Monday 29 June 2020
Re Designated Funds A27 Link Improvement Package Feasibility Study

ChiCycle Concerns, Observations and Recommendations regarding the Highways England Designated Funds A27 Link Improvement Package Feasibility Study Plans

Figure 6.1 Potential conflict issues at cycle crossings near junctions

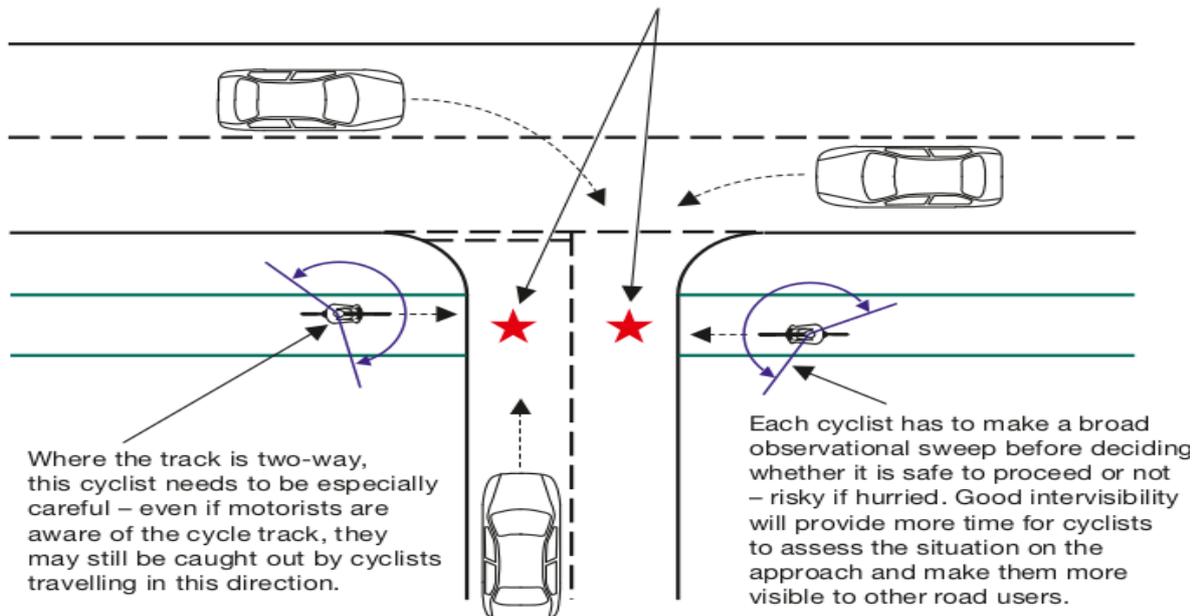
6.12 A common reason for taking cyclists off the carriageway is the perception that it will improve safety. However, it is important to understand that **a shared use route will not necessarily be safer than an on-carriageway alternative**. In particular, careful consideration is needed where a cycle track running alongside a road crosses side a road – see Figure 6.1. At these locations, there is **significant potential for conflict**, which can sometimes **negate the safety benefits** of segregating cyclists from motor vehicles. Section 10.3 of LTN 2/08 discusses this in detail.

6.13 Where cycle tracks alongside roads accommodate **two-way flow**, the **potential for conflict can increase significantly**. It is probable that drivers are less likely to expect cyclists to come from both directions because, intuitively, they might assume cyclists would be travelling in the same directions as traffic in the adjacent part of the carriageway – see Figures 6.1 and 6.2.

Motorists are likely to be concentrating on other motor vehicles when approaching the turn – they may not expect to encounter cyclists at these potential conflict points.

Figure E/3.2N Additional width required to maintain effective width of cycle tracks

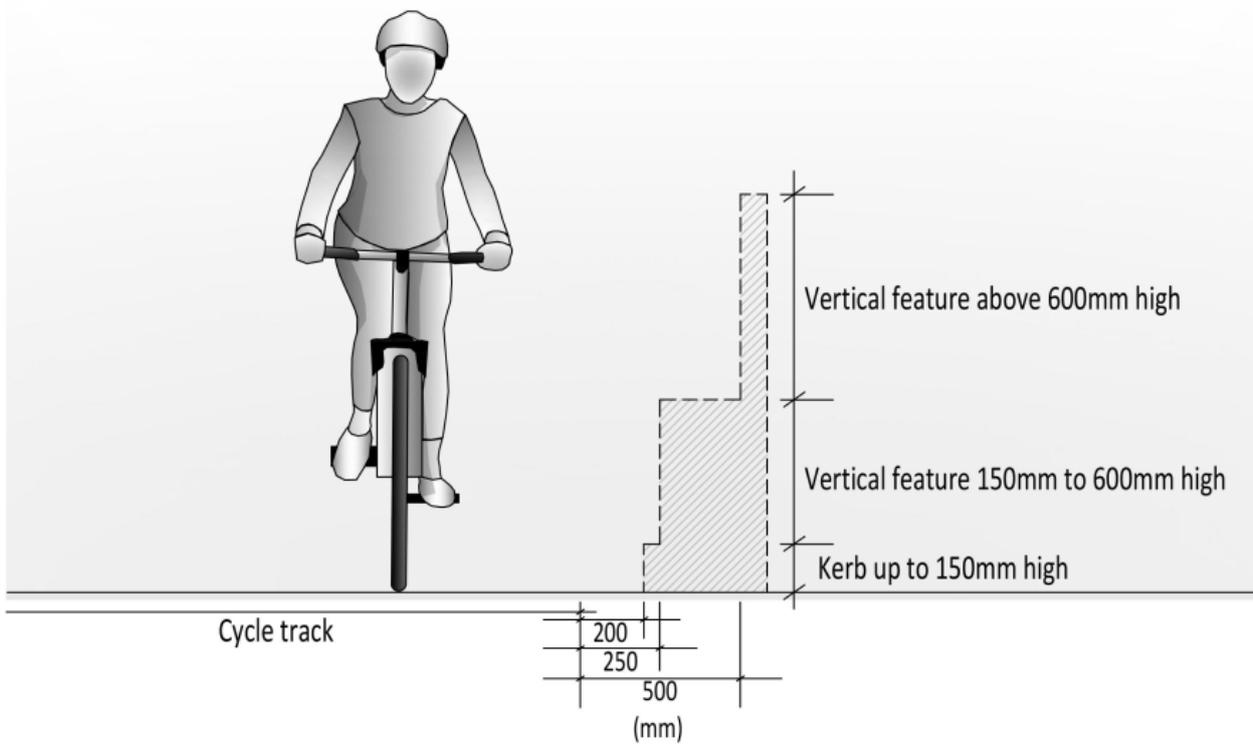
ChiCycle have surveyed sections of the A259 pavement and concluded that there has been a misinterpretation of national cycle design guidelines regarding usable track widths. Widths shown in the Feasibility Study appear not to make allowance for the vertical features adjacent to the path such as boundary walls and hedges.

As previously discussed [DMRB CD195](#) Designing for cycle traffic does not contain any specification for shared use pavements/footways. However, even if pedestrians could be removed from the pavement to make way for a dedicated cycle-way, then the standards for track widths have still been misapplied.

E/3.2 Additional width shall be added to cycle tracks to make allowance for fixed objects adjacent to or within the cycle track in accordance with Table E/3.2.
